01 November 2021

Urgent Medical Device Correction QIAcube® Connect MDx Instrument REF 9003070

QIAcube Connect MDx User Screen Issue – October 2021

Figure 1 – Run Set-Up Screen

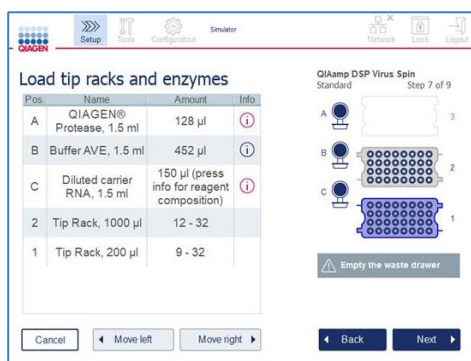
The issue relates to information given during run set-up, which is intended to guide the user on the volumes of reagents to be added to the tube. During the “Load tip racks and enzymes” step of the run set-up, users have the option to access more detailed information by clicking the **Info** button  as shown in Figure 1. The screen then switches to a similar screen, as shown in Figure 2, containing the information that a **minimum volume** is to be added instead of the exact volume as detailed in Figure 1.

If a user misunderstands the guidance on the info screen (Figure 2) and pipettes more than the recommended volume detailed on the run set-up screen (Figure 1), it is possible that the tubes will then contain either too much or not enough reagent. This could lead to an over diluted, under diluted, or improperly lysed sample, which in turn would affect downstream processing, leading to a false negative or false positive result, should it not be realized that there has been an issue with sample preparation process.

1. Follow instructions in the run set-up menu initial screen (Figure 1) and ensure that the volume detailed within the run set-up screen is adhered to using an actual volume only.
2. Upgrade to the latest version of the protocol which is due for release by 01 December 2021 and will be available at www.qiagen.com in the the QIAcube Connect MDx instrument product page. Apart from correcting the protocol text, no other changes to the protocol will be implemented.
3. Complete the Acknowledgement of Receipt form attached in this letter and return it to QIAGEN ASAP.

Figure 2 – Screen display after pressing

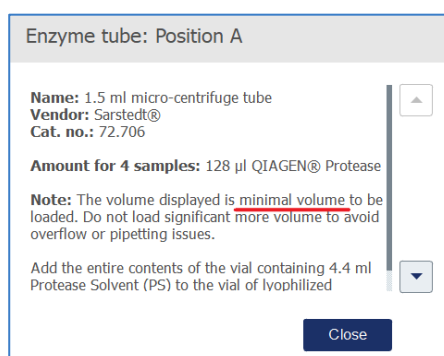
While the actual amount indicated is accurate, the additional information provided in the Note section does not clearly state that this volume should be exactly loaded onto the instrument.

QIAGEN have assessed the risk of the issue occurring during routine use of the affected protocol and have determined that this notification should be provided to all customers to ensure that they are informed to follow the information given on the screen in Figure 1 and to ignore the statement of the 'minimal volume' on screen 2. Once the customer is aware of the issue, it would be a suitable mitigation to avoid the risks highlighted within this communication.
